REVISED ADDENDUM NO. 1

Date: June 21, 2023
Project: **TWAS Enclosure/Sludge Basin and Reception Pad**
Job No.: 12600-07

**CIVIL
SITE AND HORIZONTAL CONTROL**

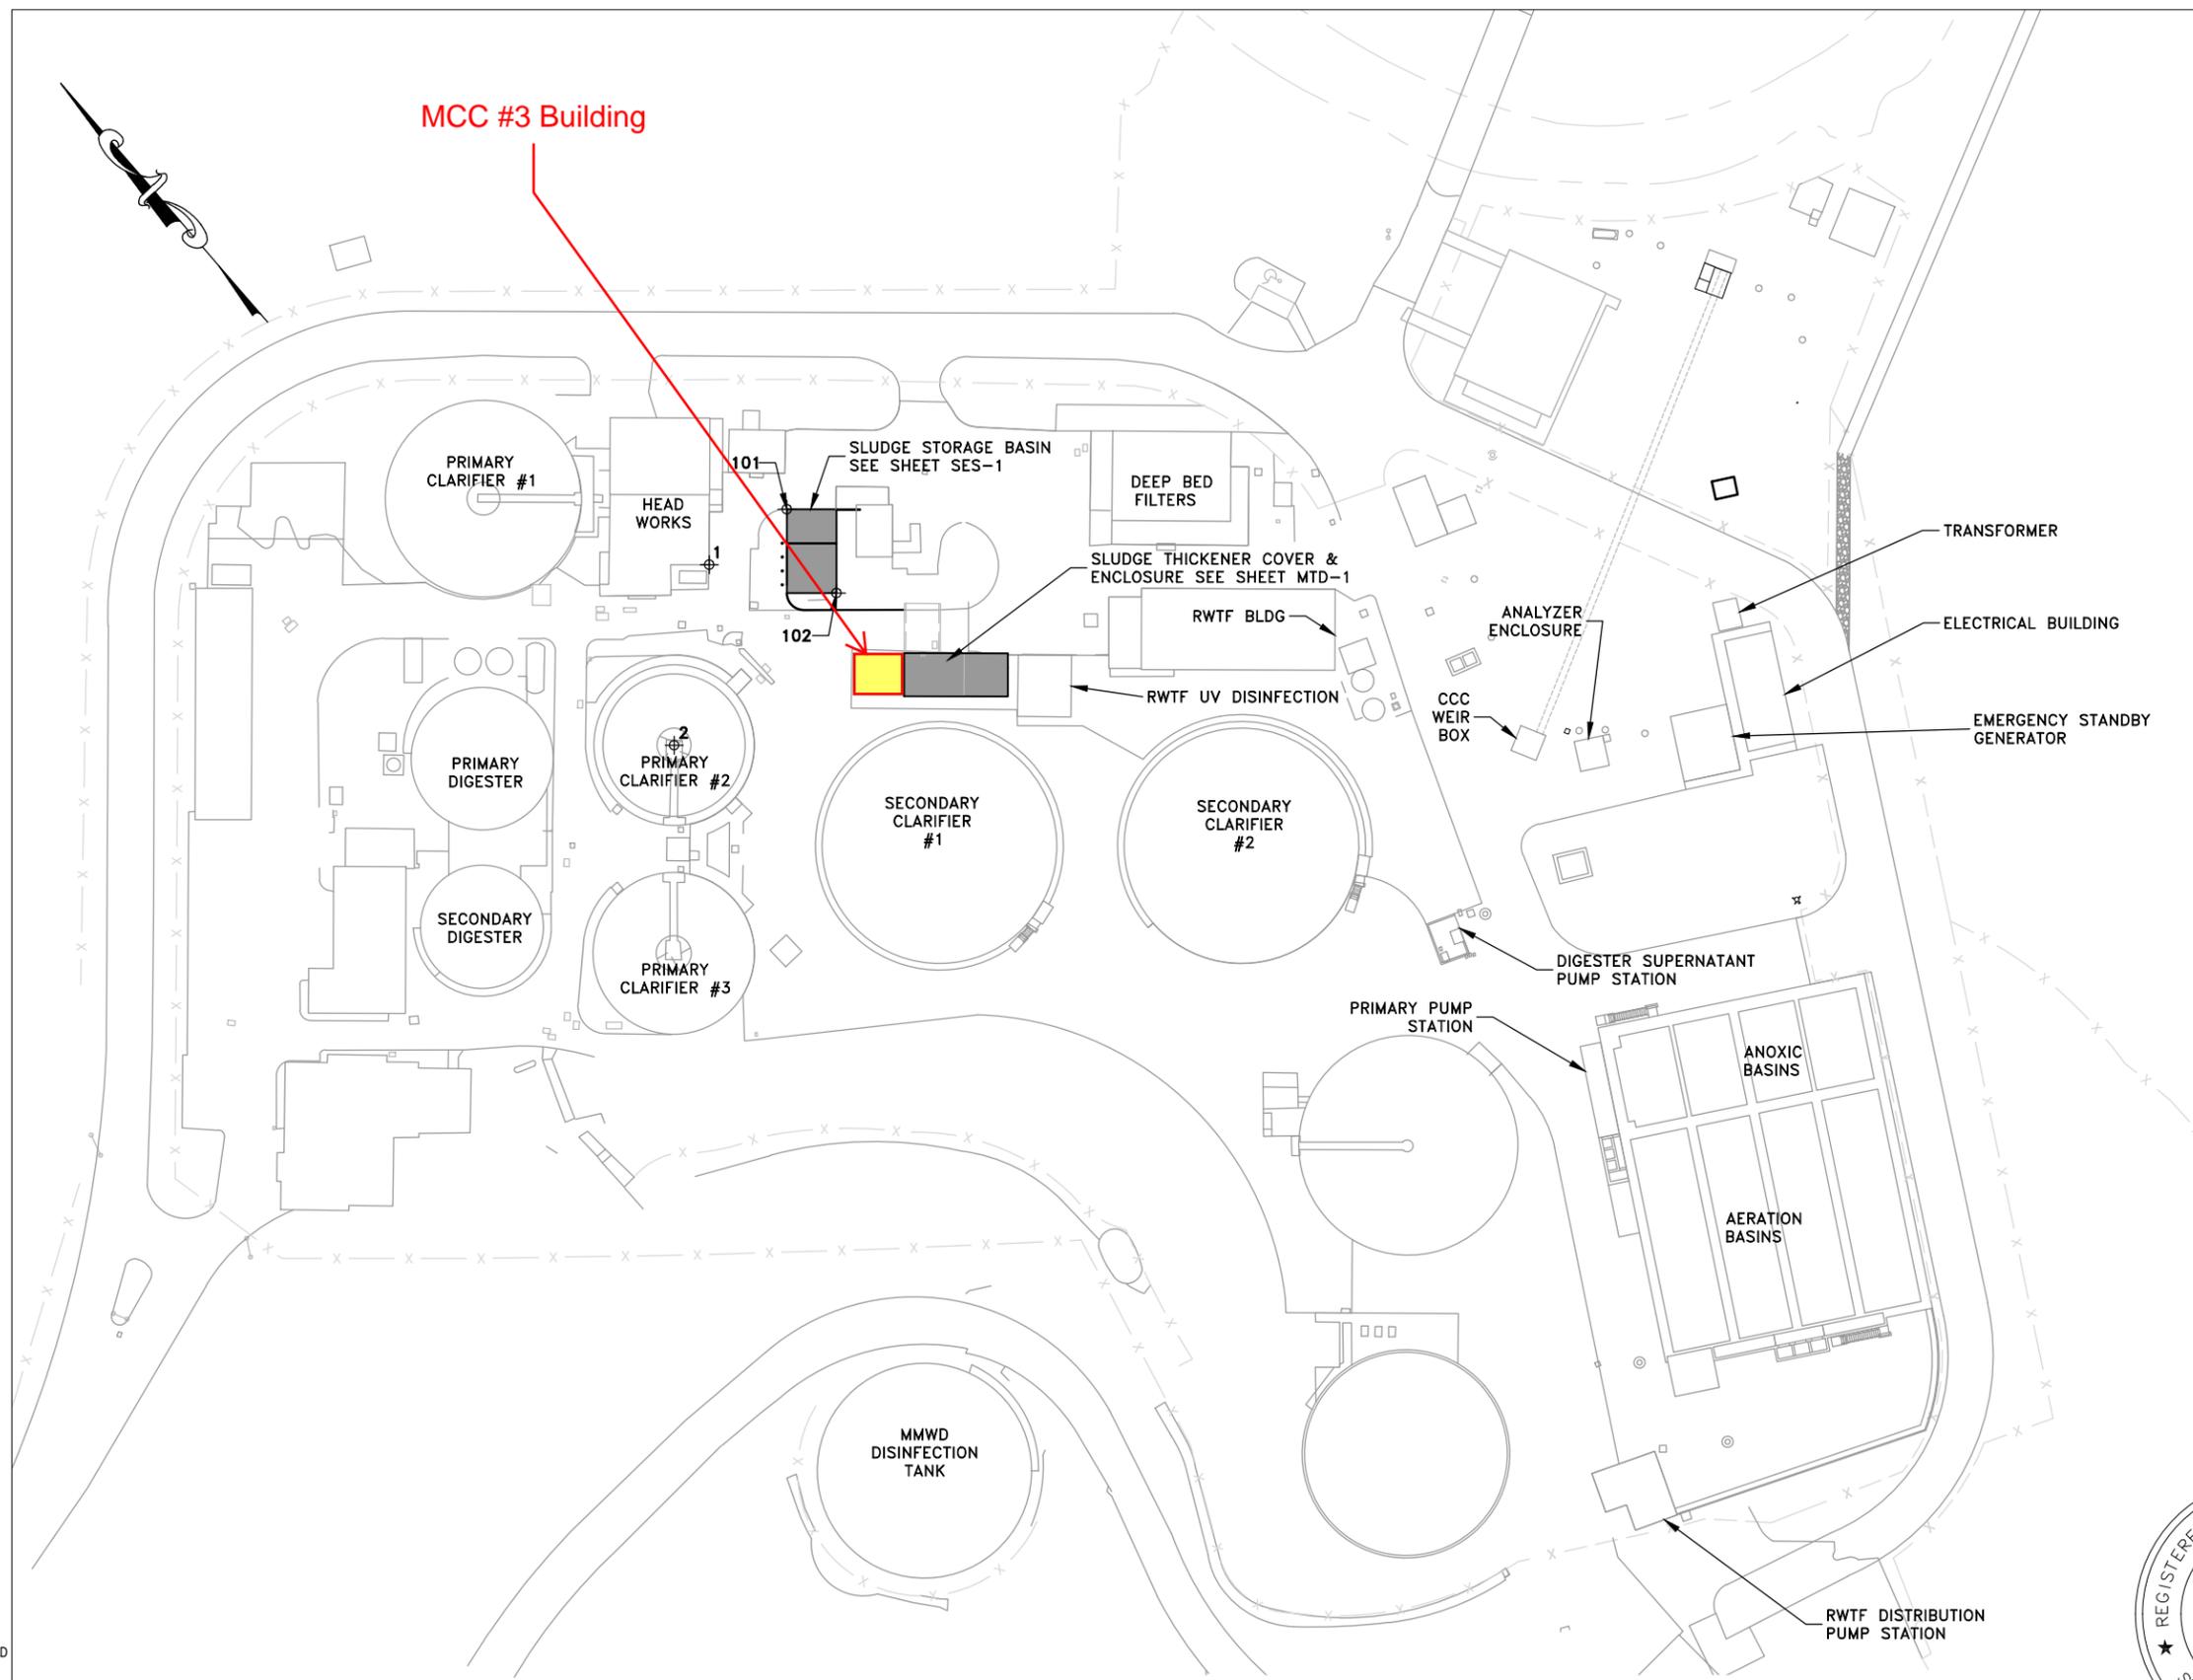
2. Where is MCC3 Building in relation to the Sludge Basin? MCC3 building does not appear to be labeled on Drawing SE-01. Please advise.

Response: The MCC #3 Building is existing and located adjacent to the proposed TWAS awning structure. The building has been highlighted in the attached versions of sheet C-1, C-2, and SE-01 for reference.

**ELECTRICAL - SITE
 SITE PLAN 1**

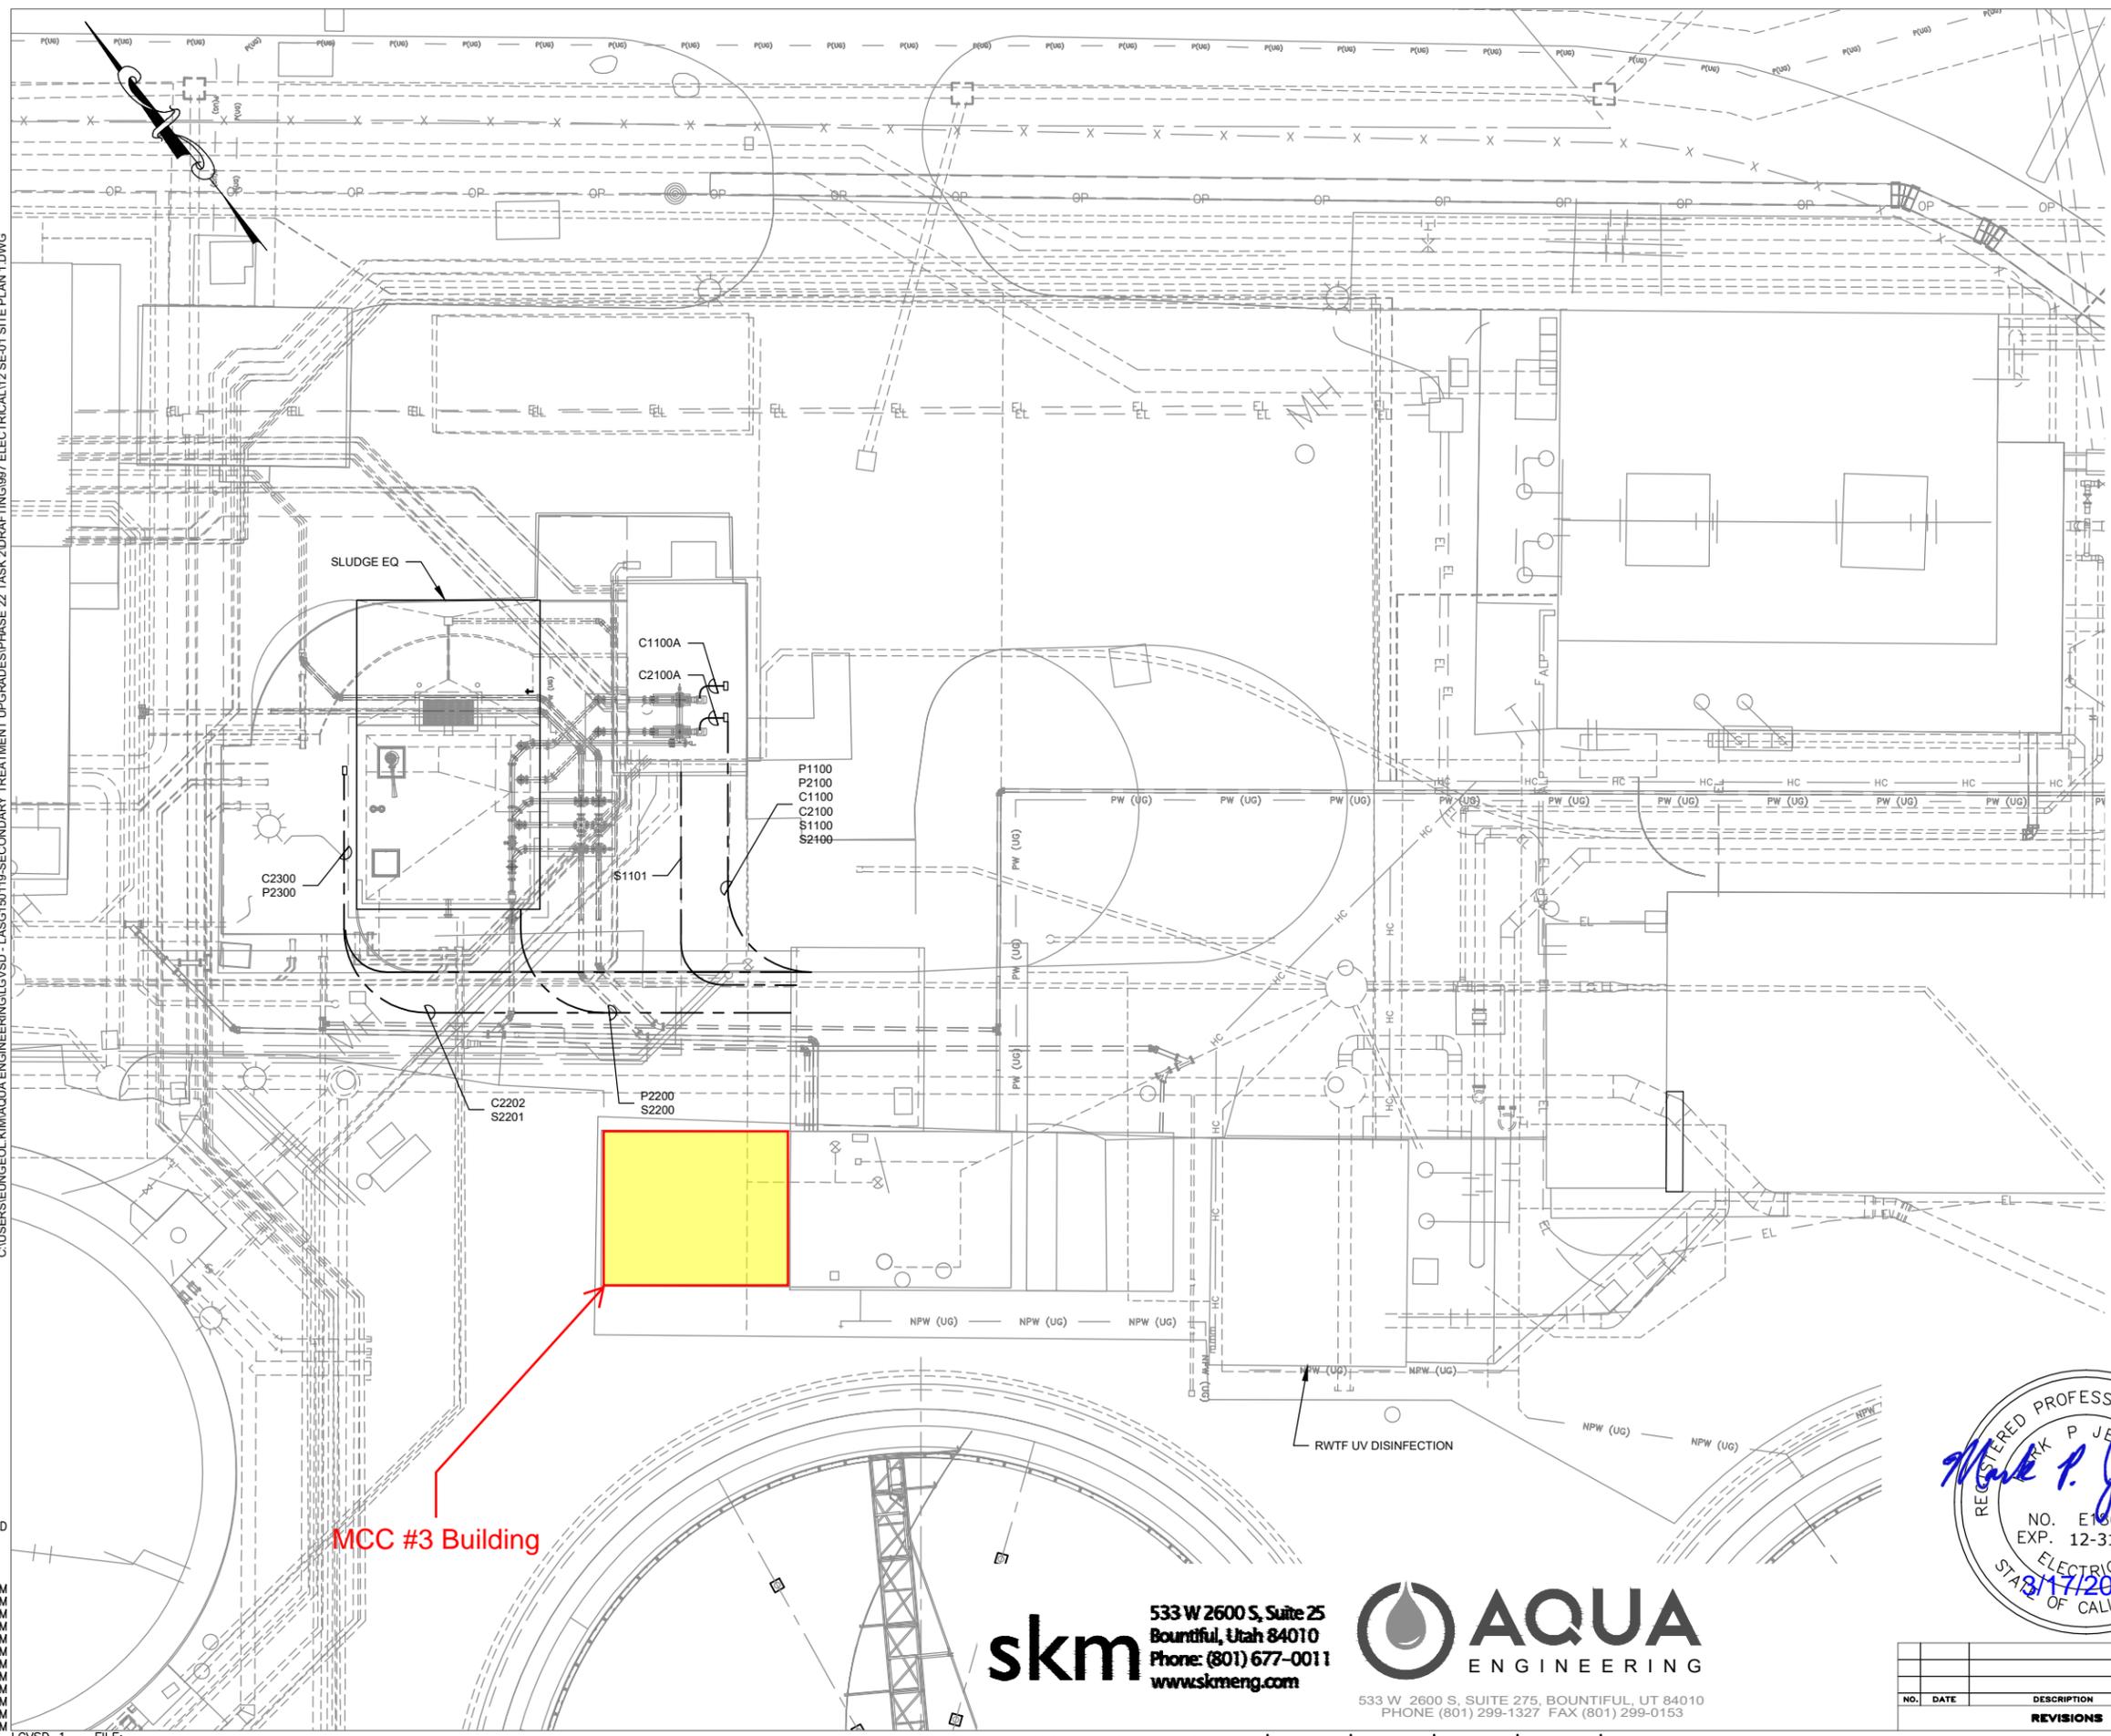
4. Electrical Legend on SE-01 appears to call for New Site Light and Pole with Photocell to match existing, however, no new lights are shown on the drawings. Please confirm if new site lighting is required and if so, provide location(s).

Response: There is no new site lighting required for this job – that note is a relic from an already-completed project and will be removed in the conformed drawing set.
